TECHNICAL BULLETIN

GOT-A-0287-A

Change to the Power Supply Voltage Description on the Rating Plates of the GT2105, GT2104, and GT2103 Models

2 Changes to the rating plate

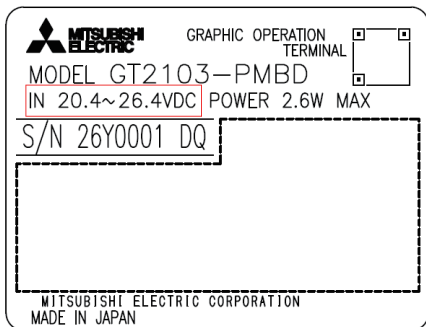
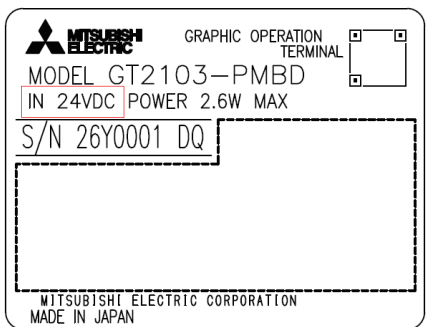
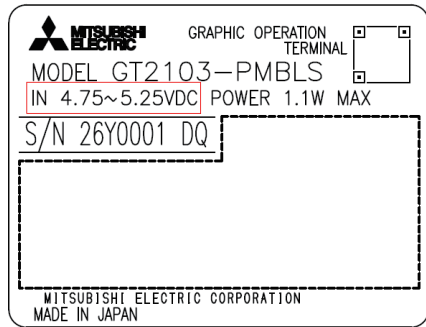
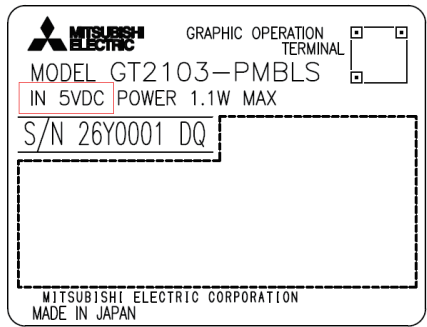
GOT		Details	Remarks
Model	Model name		
GT2105	GT2105-QTBDS	Change to the power supply voltage description on rating plate IN: 20.4 to 26.4 V DC → IN: 24 V DC	There are no changes to the power supply voltage specifications. Manual specifications: 24 V DC (+10%, -15%)
	GT2105-QMBDS		
GT2104	GT2104-PMBD GT2104-PMBDS GT2104-PMBDS2	Change to power supply voltage description on rating plate IN: 20.4 to 26.4 V DC → IN: 24 V DC	There are no changes to the power supply voltage specifications. Manual specifications: 24 V DC (+10%, -15%)
	GT2104-PMBLS		
GT2103	GT2103-PMBD GT2103-PMBDS GT2103-PMBDS2	Change to power supply voltage description on rating plate IN: 20.4 to 26.4 V DC → IN: 24 V DC	There are no changes to the power supply voltage specifications. Manual specifications: 24 V DC (+10%, -15%)
	GT2103-PMBLS		
		IN: 4.75 to 5.25 V DC → IN: 5 V DC	Manual specifications: 5 V DC (±5%), supplied from the PLC

Before	After
